Title - Sujet Construction hangar et chenil	
Solicitation No. - N° de l'invitation EF937-210361/A	Amendment No. - N° modif. 009
Client Reference No. - N° de référence du client R.100341.001	Date 2020-08-26
GETS Reference No. - N° de référence de SEAG PW-\$MTC-035-15787	
File No. - N° de dossier MTC-0-43041 (035)	CCC No./N° CCC - FMS No./N° VME
Solicitation Closes - L'invitation prend fin at - à 02:00 PM on - le 2020-09-03	Time Zone Fuseau horaire Heure Avancée de l'Est HAE
F.O.B. - F.A.B. Plant-Usine: <input type="checkbox"/> Destination: <input type="checkbox"/> Other-Autre: <input type="checkbox"/>	
Address Enquiries to: - Adresser toutes questions à: Lussier, Joël	Buyer Id - Id de l'acheteur mtc035
Telephone No. - N° de téléphone (514) 708-3582 ()	FAX No. - N° de FAX (514) 496-3822
Destination - of Goods, Services, and Construction: Destination - des biens, services et construction:

INVITATION TO TENDER
Hangar construction and Kennel extension
Rigaud, Que

This amendment 009 is raised for :

- Questions and Answers from bidders

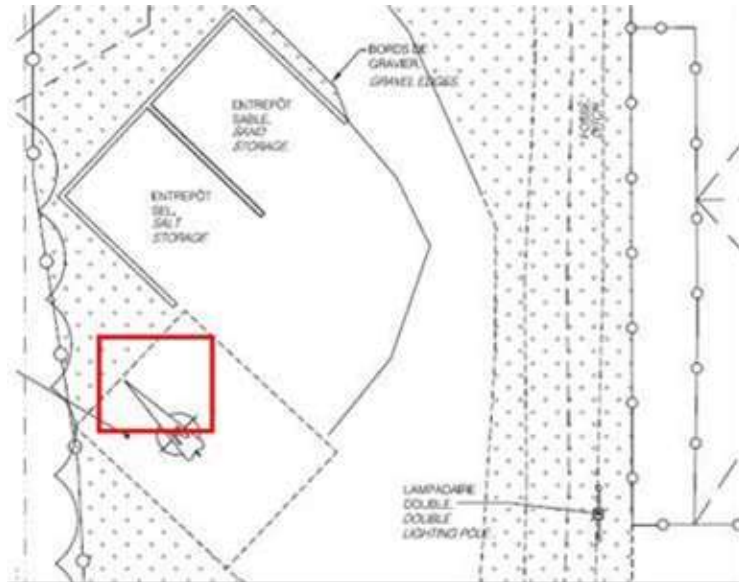
2-Is there a truck access inside the site for deliveries?

4-Is it possible to have an electrical connection from the old hangar?

2-No, the contractor cannot use the College's delivery dock. All construction deliveries must be made directly to the construction site.

4-An electrical connection is available from the location indicated in red :
